**Bulletin**

MODEL BENTLEY MARK VI

FOR INFORMATION:FRONT SHOCK DAMPER SETTINGS.Increased Bump Load.

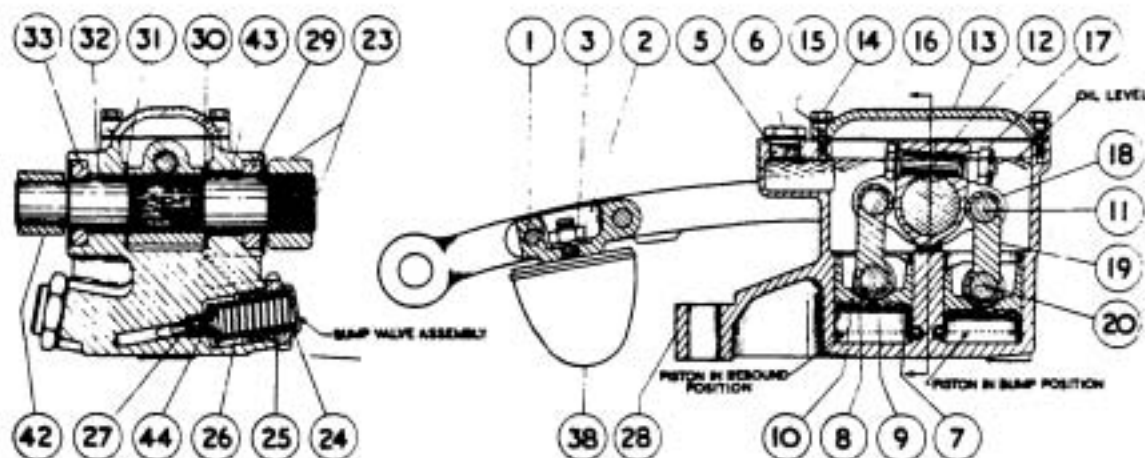
4. Remove the bump valve cap (24), aluminium washer (25) bump valve spring (26), bump valve (27), also any packing washers which may be fitted between the spring and the cap.

Clean the parts and replace in the damper using a new bump valve spring in place of the old one which was removed, also remove any packing washers, but do not tighten the valve cap.

This Bulletin describes the procedure for raising the loading of the bump valve by replacing the existing bump valve spring with a new spring of increased strength, raising the bump loadings to 95-105 lbs., the rebound loading remaining unaffected. The part number of the spring giving the 95-105 lbs. bump loading is RF.5022, these are obtainable from Hythe Road Service Depot.

FIG. 5. MODIFICATION TO SPRING COMPRESSING TOOL.

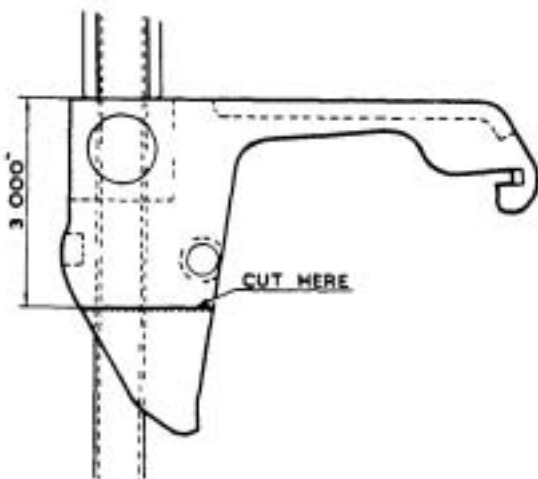
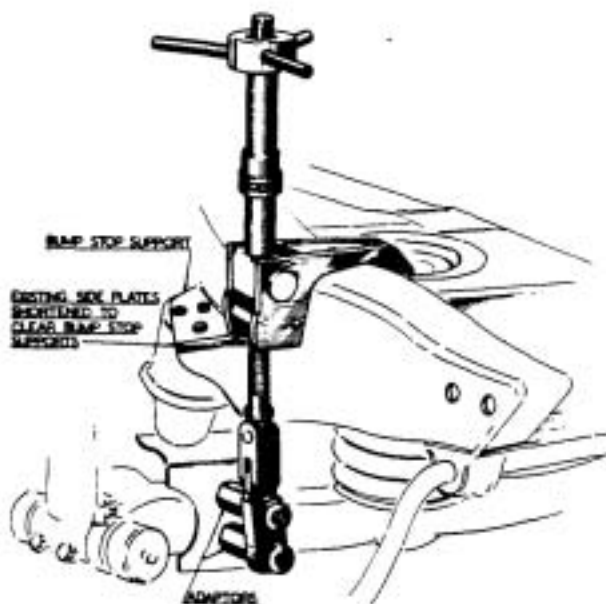
In order to make the early type front spring compressing tool suitable for all types of chassis, the side plates of the clamp should be shortened to the dimension shown in Fig. 5. A modified tool in this respect is shown in position in Fig. 6. The later type production of this tool has shortened side plates.

On certain chassis it may be necessary to screw two adaptors (extension pieces) on to the two  $\frac{1}{2}$ " (B.S.F.) studs at the front of the torque arm in order that a straight pull can be obtained with the tool when compressing a spring. These adaptors are shown in position in Fig. 6. They are not supplied but can be made in accordance with details given in Fig. 7.

FIG. 3.

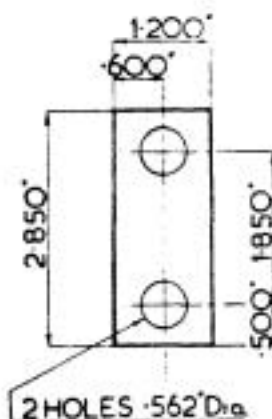
The only way of altering the castor angle is to fit taper packings between the lower radius arm and the torque arm. Obviously in order to maintain parallelism of the shroud faces, an equal and opposite taper packing must be fitted on the outside of the radius arm i.e. between the radius arm and the bracket of the front stabiliser. Parallel packings may already be found between the torque arm and the radius arm. These are not for the purpose of adjusting the castor angle, they are fitted to line up the yoke in the upper triangle levers to avoid strain on the upper Silentbloc.

If adjustment of the castor angle in a negative direction is required, the torque arm will probably need shortening in order to line up the upper end of the yoke in the triangle levers. If it is found that a parallel packing is fitted between the torque arm and the lower radius arm, then it should be removed, which will automatically reduce the effective length of the torque arm. The required reduction in length is 0.200" (5.08 mm) for each degree of alteration in the castor angle. This of course includes any packings which may be removed. The maximum amount which may be removed from the torque arm itself is 0.125" (3.17 mm).

where castor angle is changed in a positive direction, it is possible that longer studs KB.963/Z-Torque arm will be required. A drawing of the taper packings required is given herewith (Fig.3) in order that they may be made up as required. The maximum change recommended is 1 1/2°.

FIG. 1.

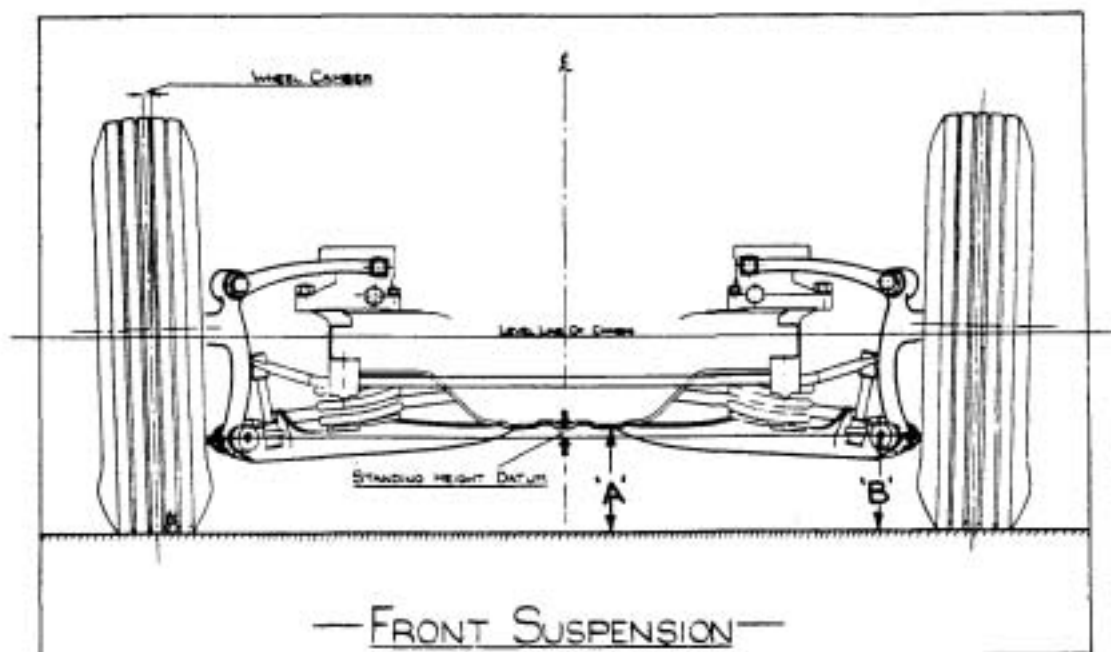
In consequence of the changes in the geometry of the radius arms mentioned above, the datum for measuring the standing height has been shifted relative to the ground as compared with the original design, and although the frame is .400" (10 mm) higher than formerly, the reduced angularity of the lower radius arms means that the measurement of standing height can now become a negative figure.

A negative reading is when dimension 'B' Fig.1 is greater than dimension 'A'  
A positive reading is when dimension 'A' is greater than dimension 'B'.

.400" (10 mm) negative  
to  
.200" (5 mm) positive

.600" (15 mm) positive  
to  
1.200" (30 mm) positive

FIG. 2.

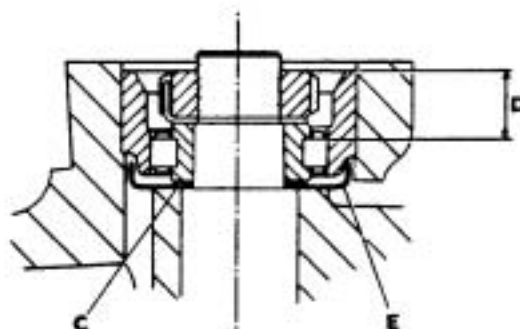
- (iii) Place a small straight-edge across the top face of the outer race of the upper roller bearing assembly of the pivot pin (not across the top face of the stub axle). With the rule or a small depth gauge, measure the distance downwards from the top face of the outer race to the top face of one of the rollers (not the brass roller cage), i.e. dimension 'D' Fig. 2 and note.

- a) If dimension 'D' is within the limits of .430" - .480" (10.9 - 12.2 mm), this is correct.
  - b) If dimension 'D' is between the limits of .480" - .515" (12.2-13 mm), then it will be necessary to remove the pivot pin and fit a .040" (1 mm) thick packing washer ('C' Fig.2), Part No.R-4468, between the oil trough ('E') and the inner roller race.

- c) If dimension 'D' is over .515" (13 mm), fit two packing washers.
- (iv) Having refitted the pivot pin and fully tightened the nut, check that the stub axle can be moved freely from one full lock to another, apart from the normal drag caused by the felt washer at the lower end of the yoke.
